**Re: Pio Pico Energy Center Project (11-AFC-01)  
Supplemental Responses to Staff's Data Requests, Set 1 (#29 and 30)**

**PIO PICO ENERGY CENTER  
APPLICATION FOR CERTIFICATION  
SUPPLEMENTAL RESPONSES TO CEC DATA REQUESTS  
11-AFC-01**

**Technical Area: Biological Resources**

**FIGURE DR-BIO 29.1**  
 CUMULATIVE NITROGEN DEPOSITION,  
 INCLUDING PROJECT CONTRIBUTION  
 (UNITS OF KG/HA/YR)

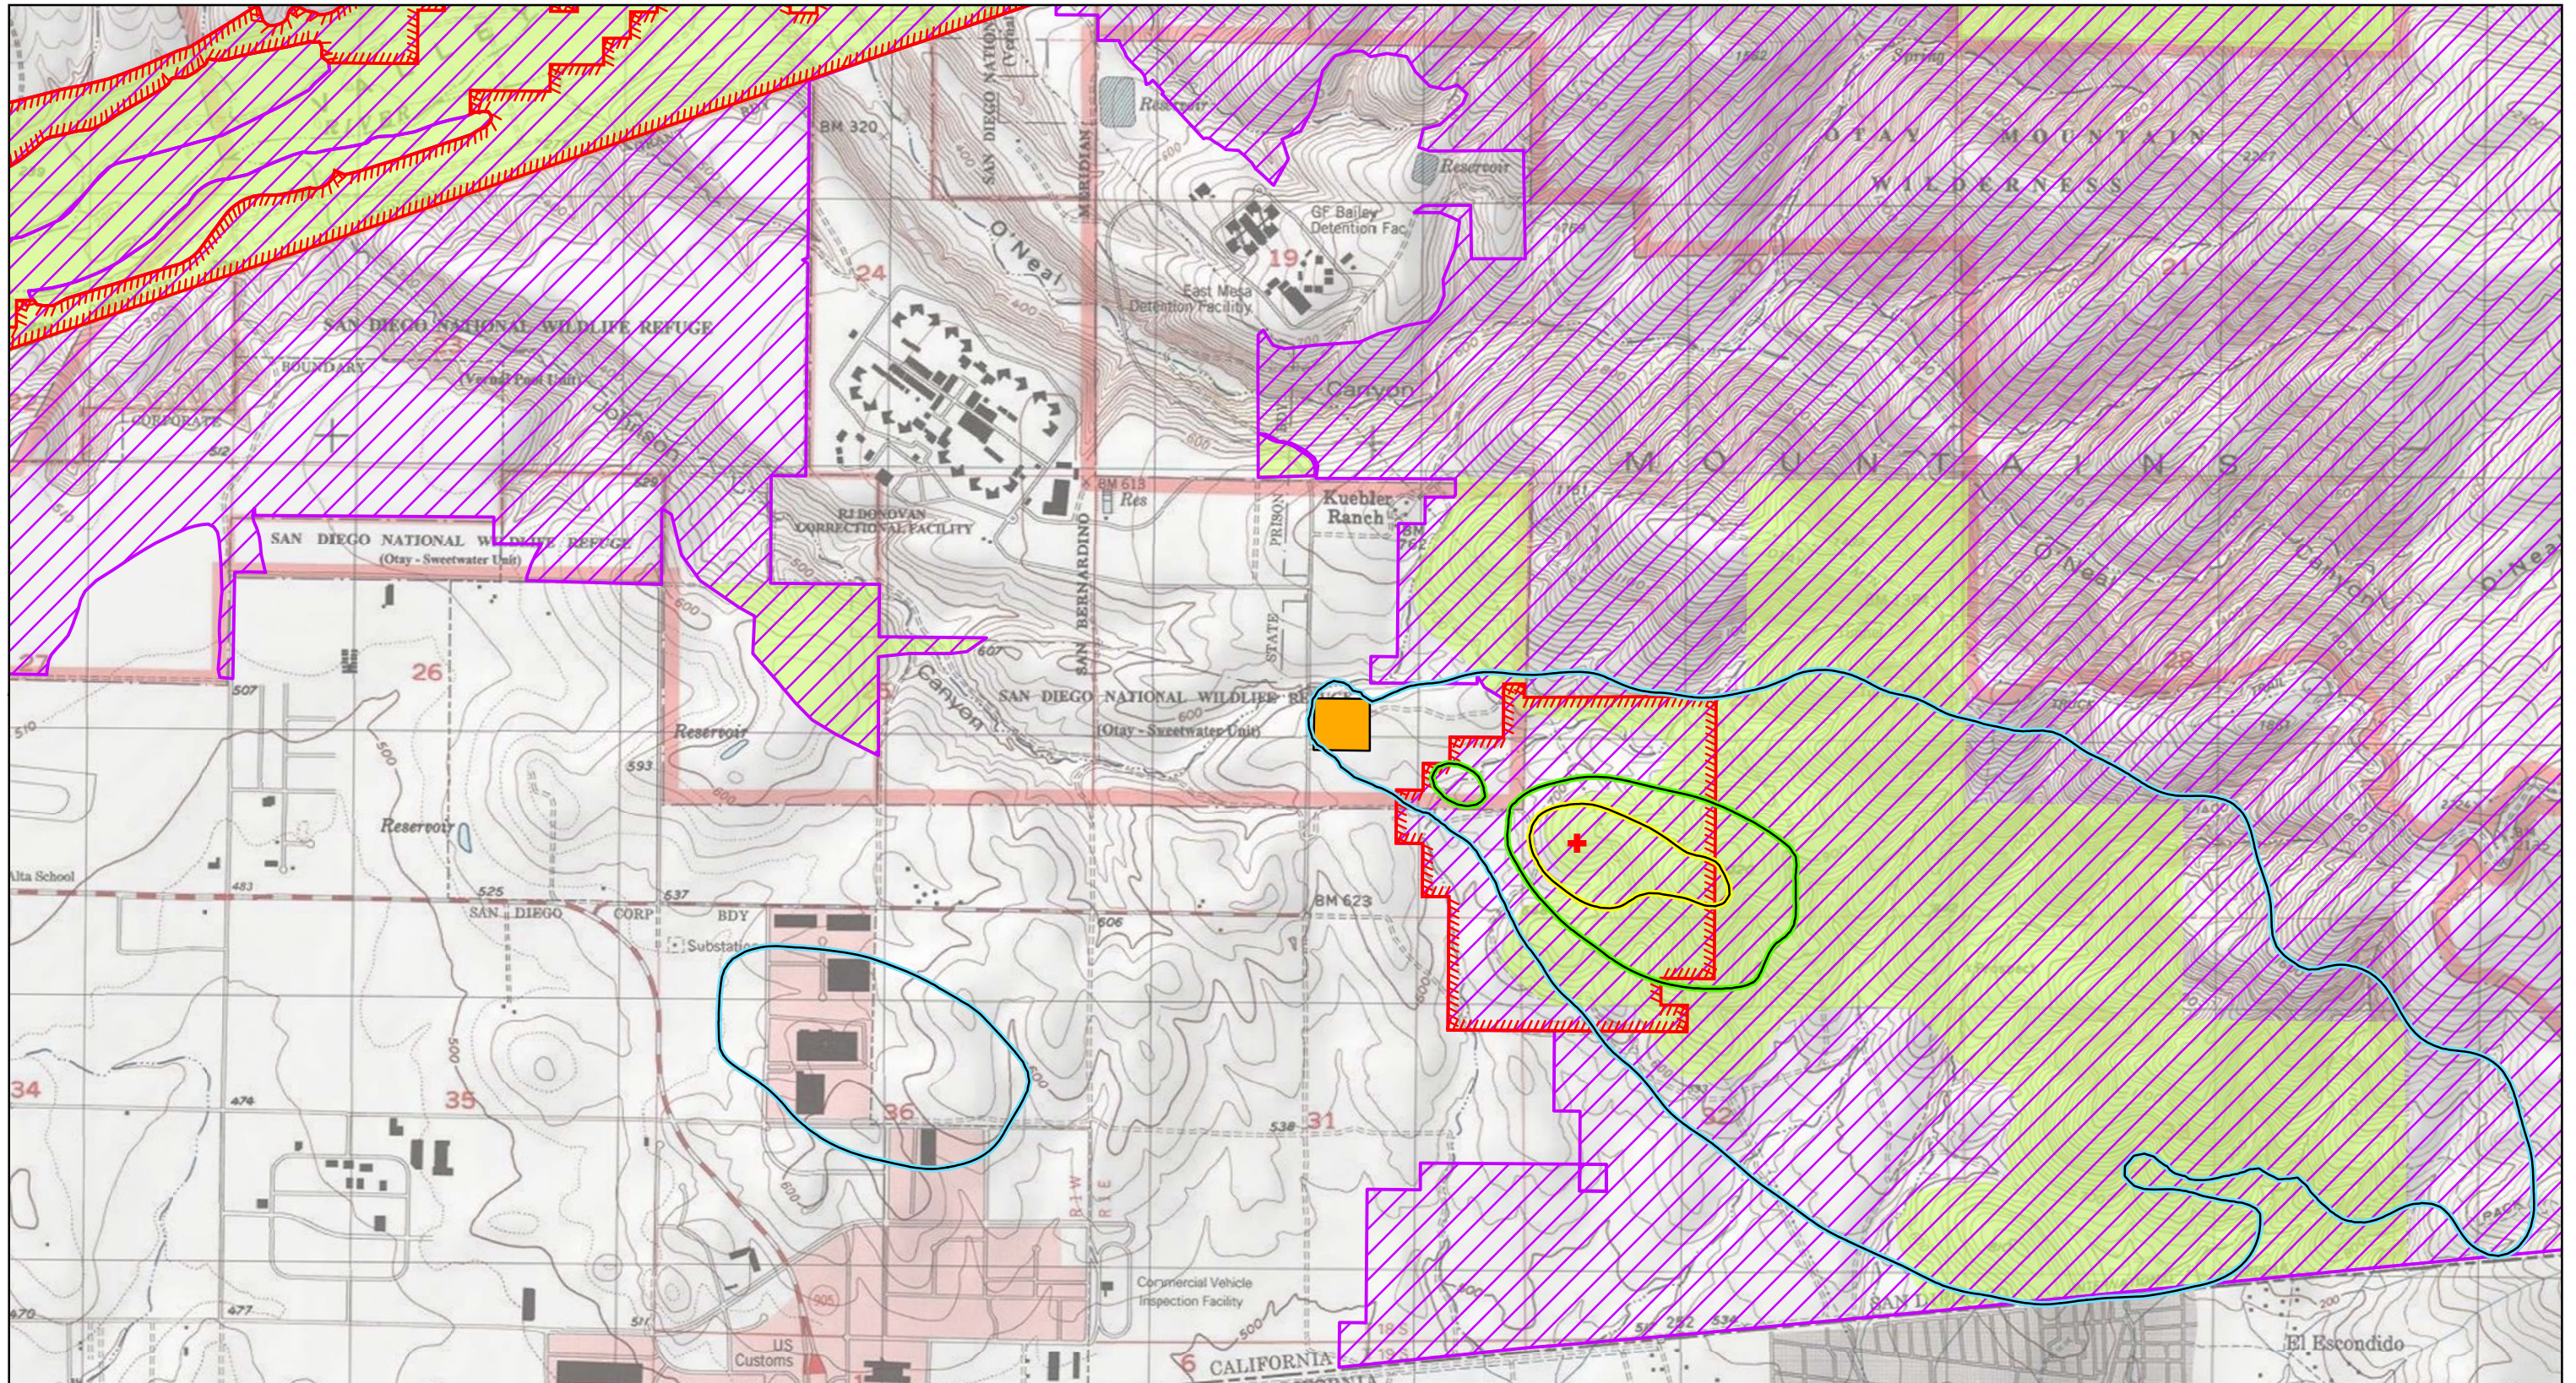
**Data Request BIO-29:** Please also provide a cumulative impact analysis of the nitrogen deposition values in kg/ha/yr. Provide an isopleths graphic over USGS 7.5-minute maps of the direct nitrogen deposition values in the cumulative analysis and specify the cumulative nitrogen deposition rate in kg/ha/yr at any affected special status habitat, vegetation type, or critical habitat. The geographical extent of the cumulative nitrogen deposition mapping should be directed by the results, i.e. extend geographically to where the deposition is considered below any stated threshold of significance.

**Response:** The requested isopleth graphic is shown in Figure DR-BIO-29.1 and includes the cumulative nitrogen deposition, with the project contribution. Figure DR-Bio 29.2 shows the cumulative background nitrogen deposition but does not include the project contribution. As shown on the aforementioned figures, the facility contributes a very small amount of nitrogen deposition (less than 6% to the regional nitrogen deposition rate). Furthermore, the proposed threshold for significance for cumulative impacts in sensitive areas (5 kg/ha/yr) is exceeded by the existing regional background, which is estimated to be 11.56 kg/ha/yr (Tonneson et. al. 2007).
